# Dendrobium Extension Project

## Residual Questions

# 7. What streams should be considered 'significant'?

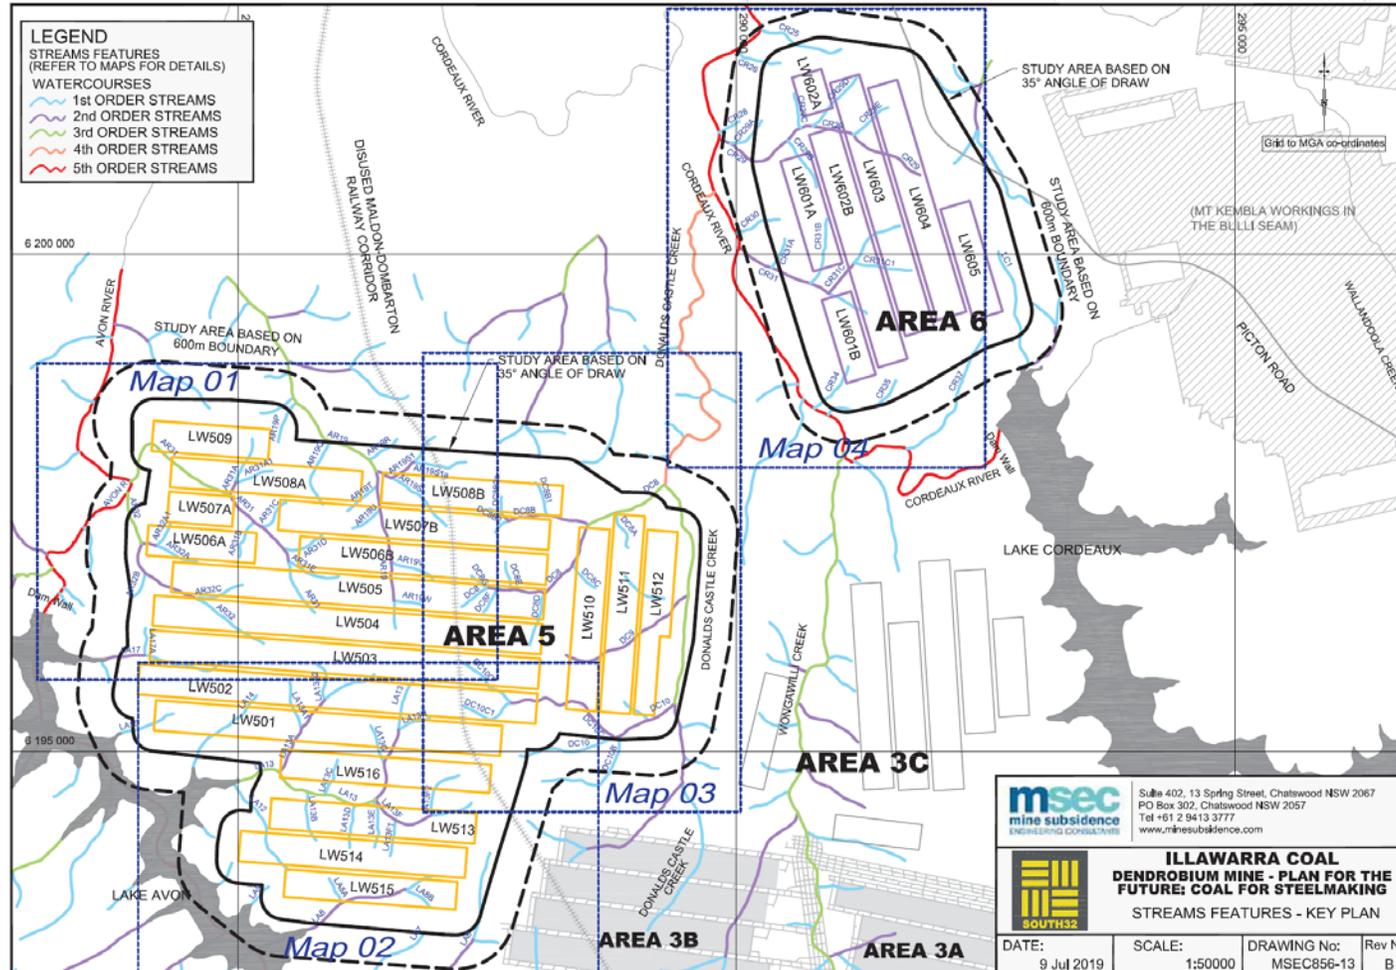
- Further consideration of 'special significance' of streams/sections/features based on IAP's risk assessment approach is warranted

- WaterNSW does not agree that unnamed necessarily means not significant (i.e. DC8, AR19, AR31 and LA13)
- WaterNSW has previously suggested further protection for key 3<sup>rd</sup> order watercourses
  - shifting the western end of LW509 by approximately 150 m to the east (AR31)
  - shifting the western end of LW516 by approximately 100 m to the east (LA13)
  - shifting the northern end of LW510 by approximately 400 m to the south (DC8).
- Aerial assessment would be useful in any assessment
